ADA Curb Ramp New Construction Inspection Form (Perpendicular)

Nw 289 ave

24952.54

Nw Keenon st

PERPENDICULAR RAMP (PR)

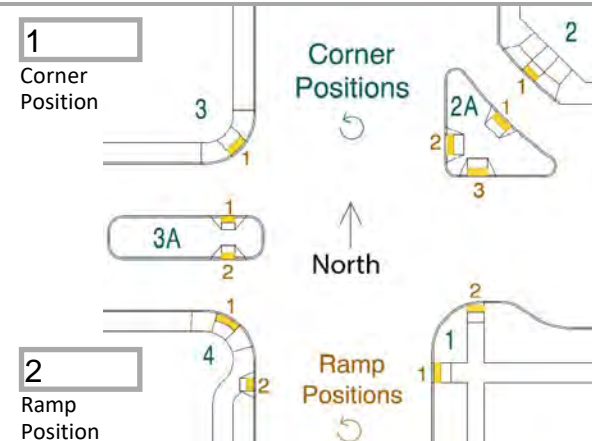
Large longitudinal crack
